FW: Response the Departmental Comments - Planning Application No. A/YL-PH/1092
Drainage Detail and Section.pdf; HYDRAULIC CALCULATION SHEET.pdf; Site Photo.pdf;
回應渠務署意見 4-12-2025.pdf

尊敬的渠務署：

Project: Proposed Temporary Public Vehicle Park at DD 111, Ha Che, Pat Heung, Yuen Long

Planning Application No.: A/YL-PH/1092

修改後的排水計劃圖 (圖則編號：DP-01)

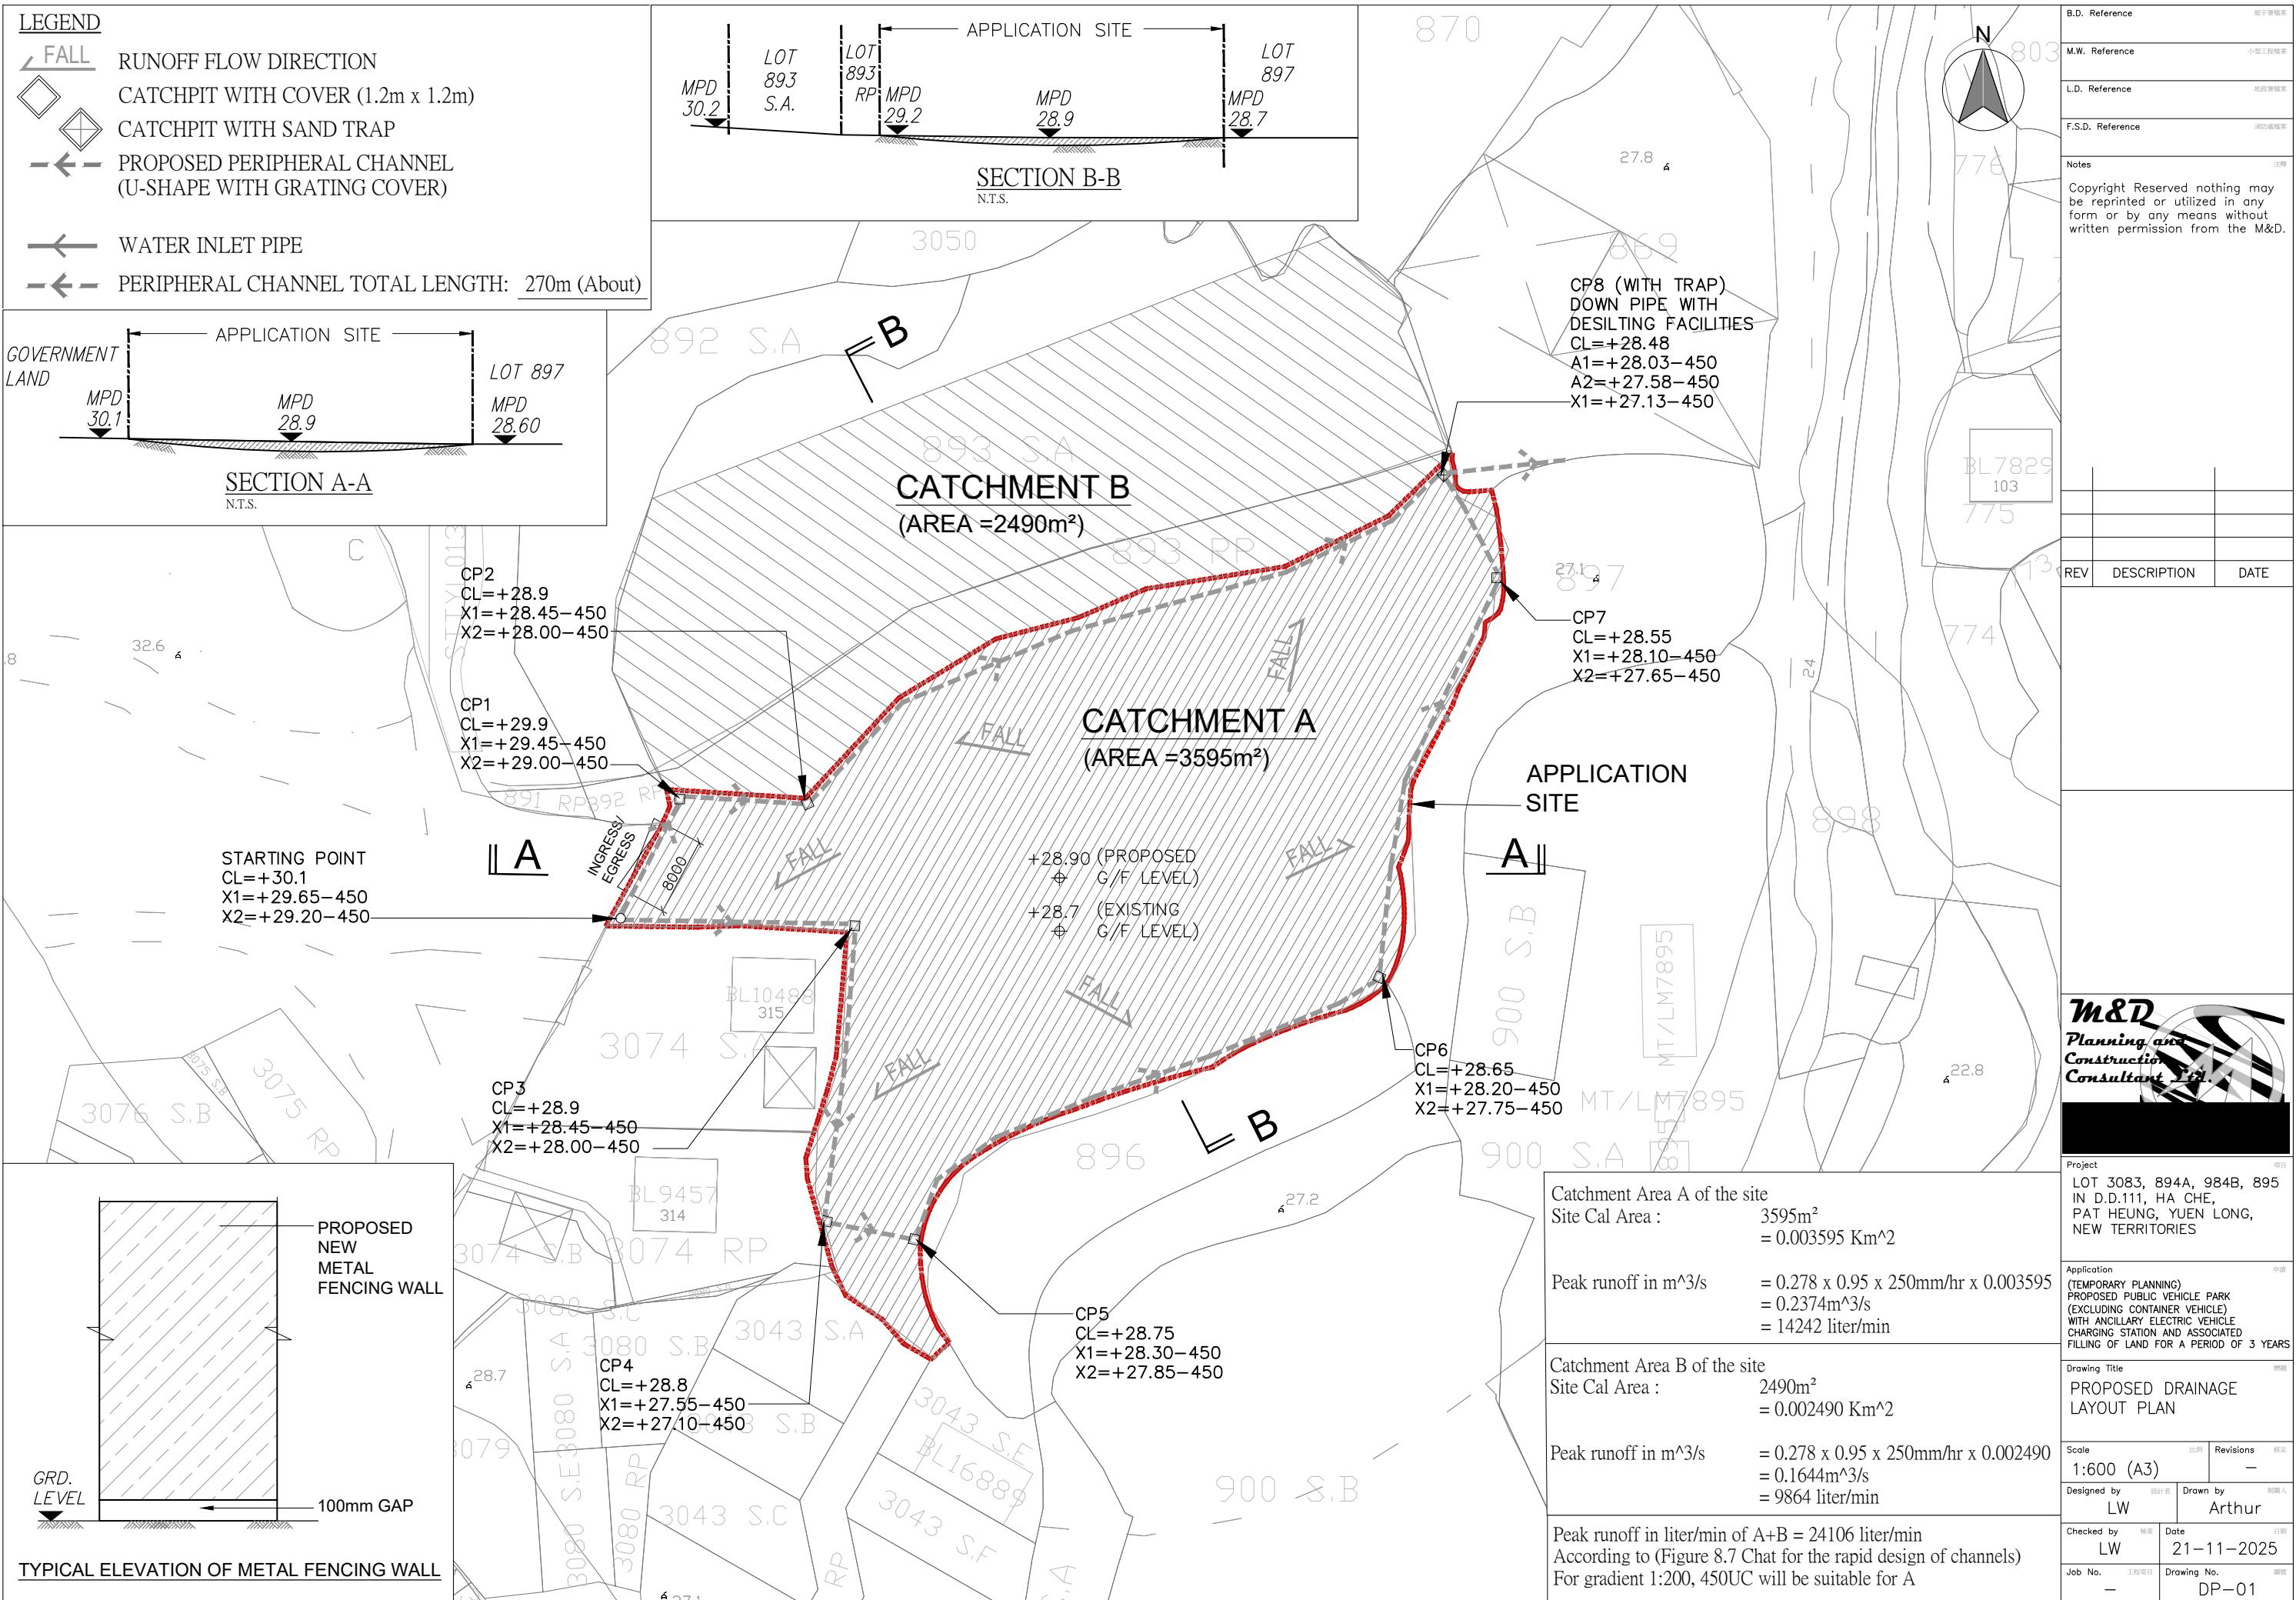
2. 針對意見 (d) 及 (h)：北側渠道水平與截面圖

在圖紙中新增截面圖 A-A，清晰標示現有地面水平、擬議地面水平及渠道底水平。

回應：我們已通過截面圖證明北側渠道水平 (28.48mPD 至 29.9mPD) 不會阻礙鄰地徑流。

證明渠道設計能有效引導地表徑流。

Figure 8.10 - Typical Details of Catchpits

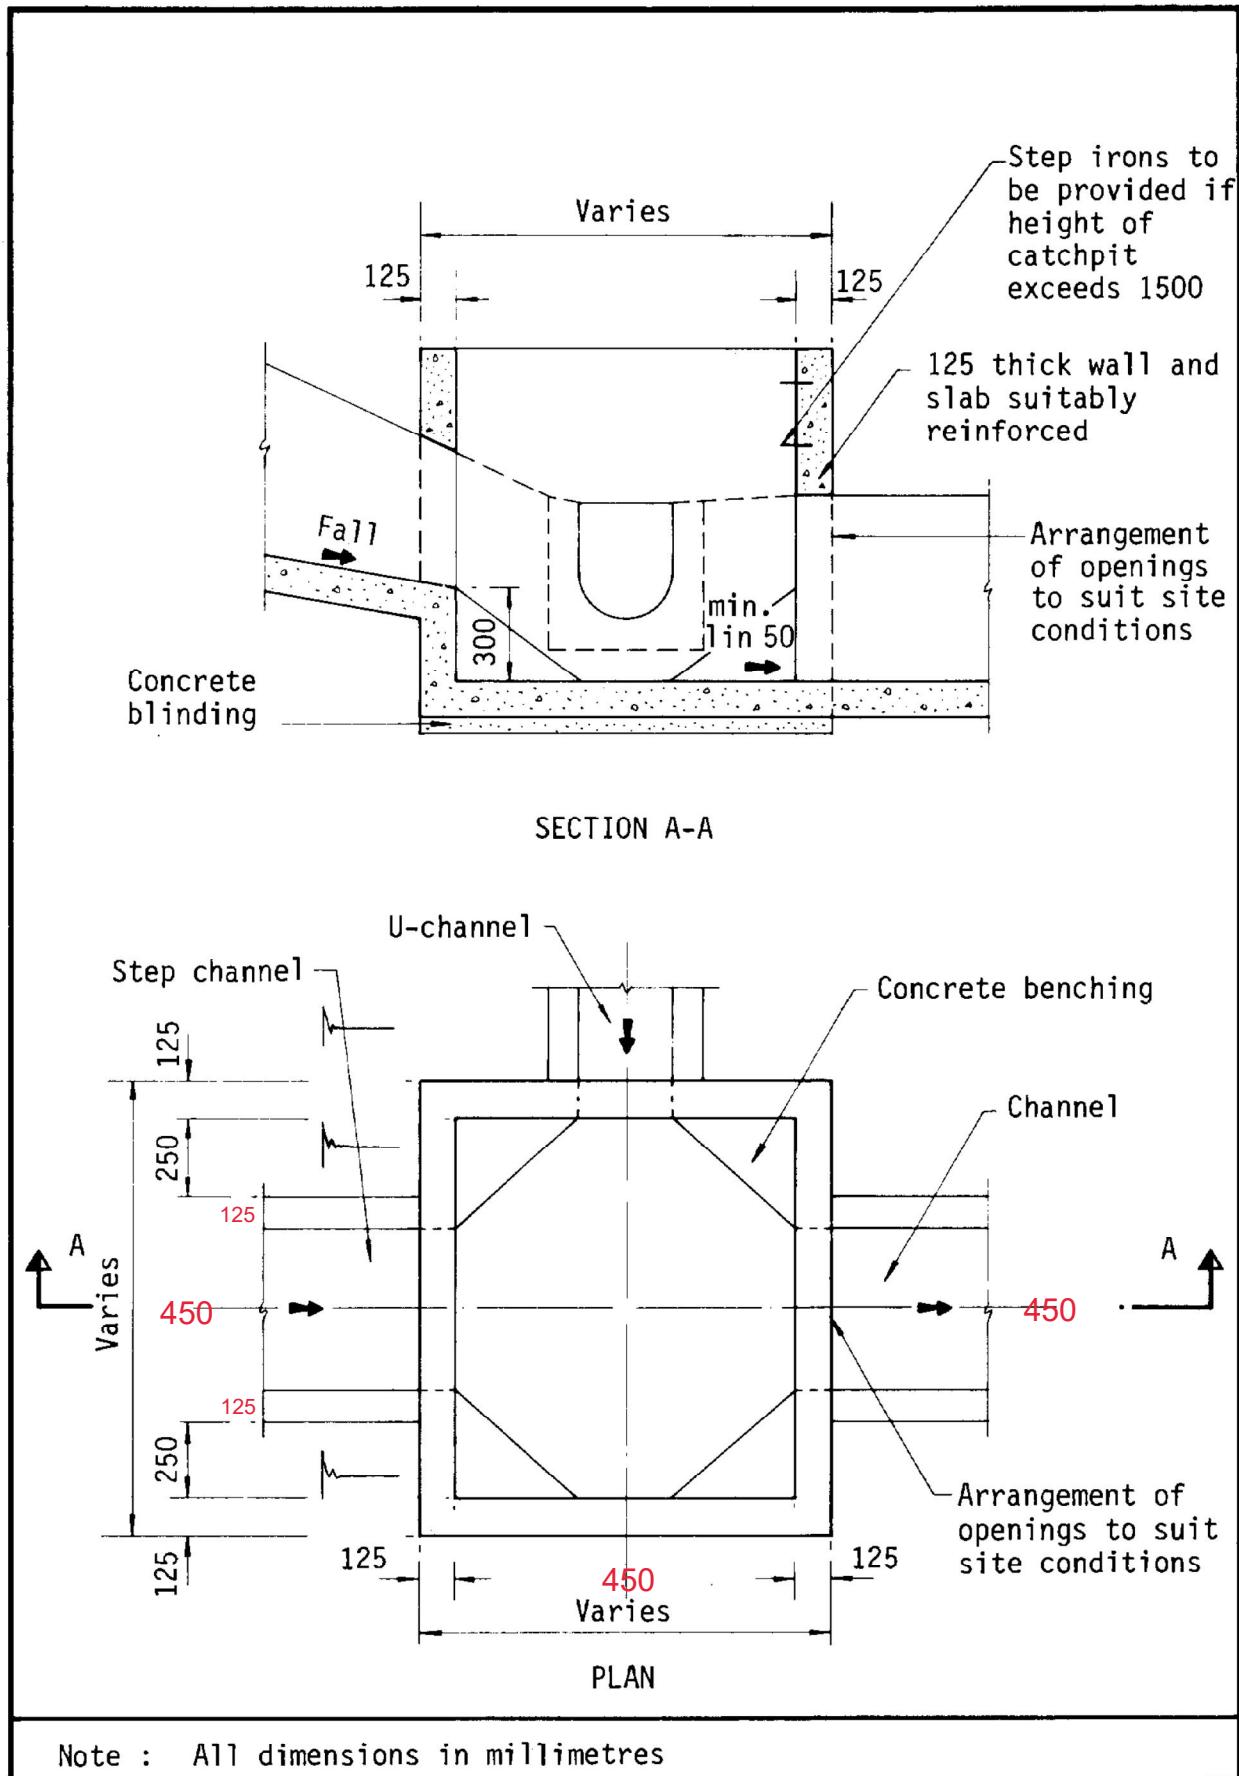
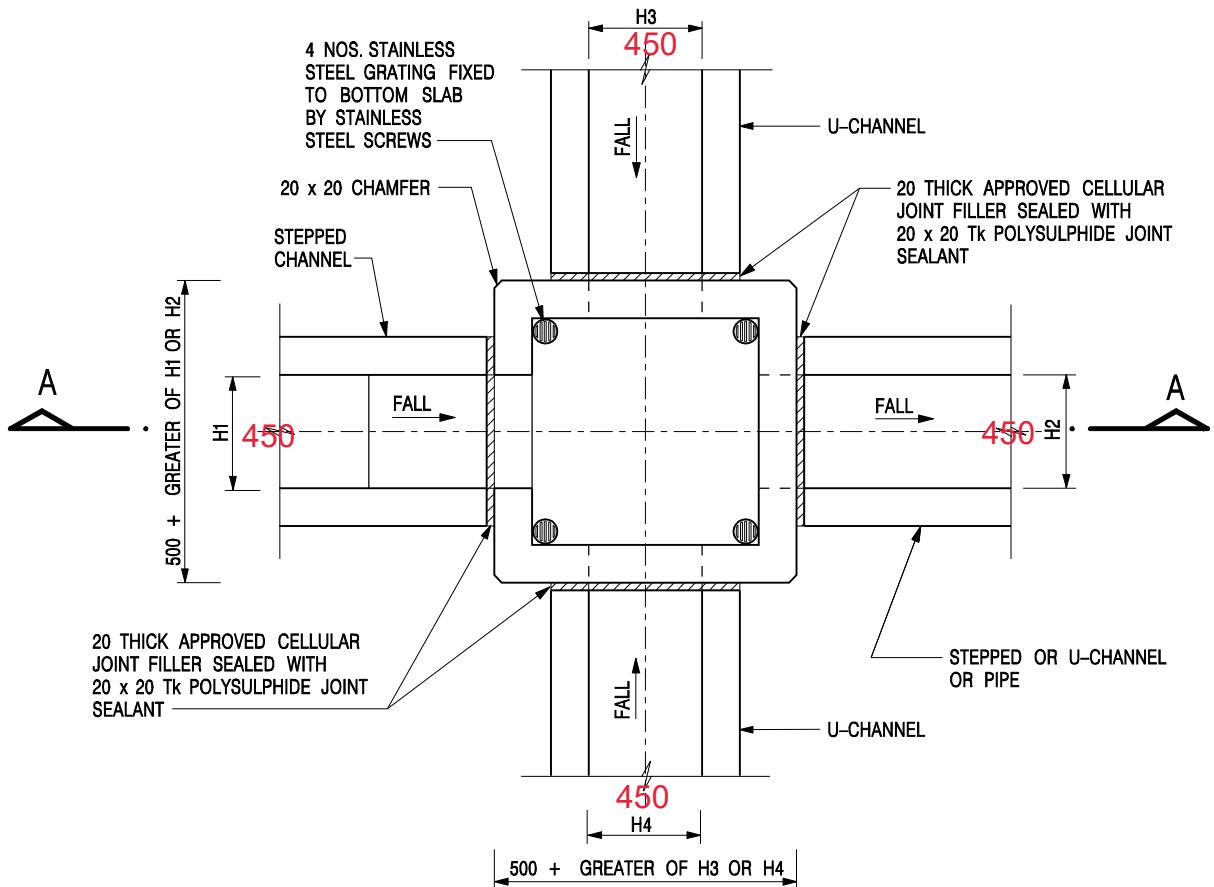
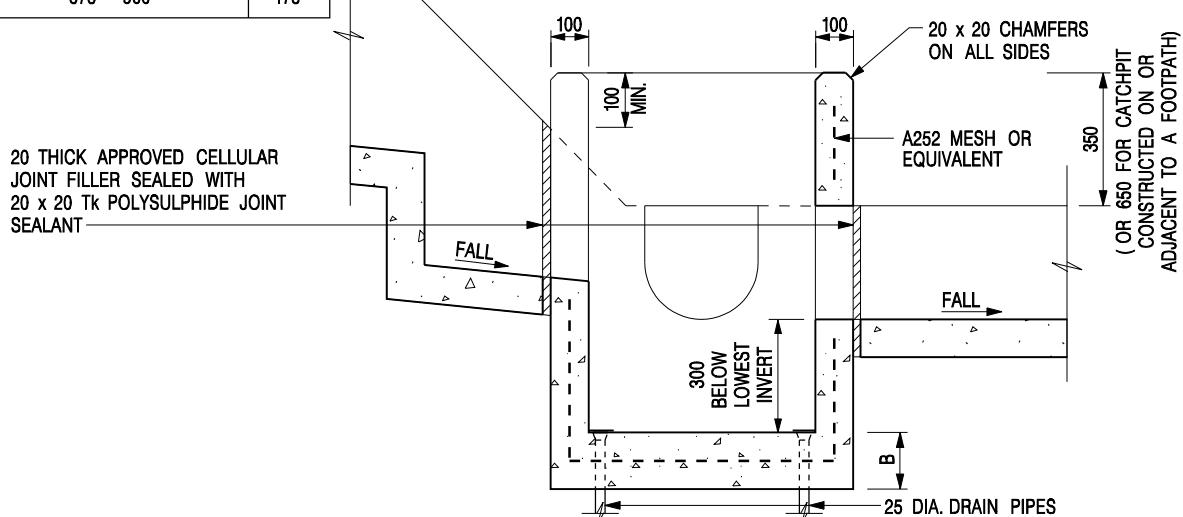
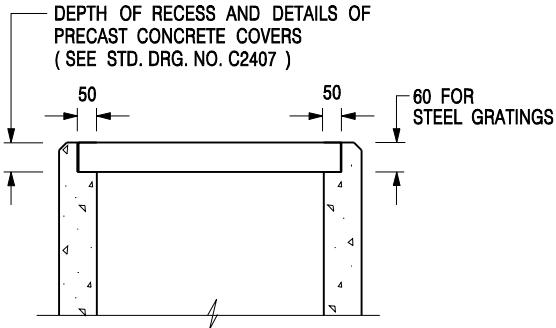
4. 針對意見 (f) 及 (i)：U 形渠與集水井標準詳圖

回應：我們已根據渠務署技術通告第 1 號提供標準詳圖。

在圖紙中新增 U 形渠與集水井/沙井的截面詳圖，包括材質與規格。
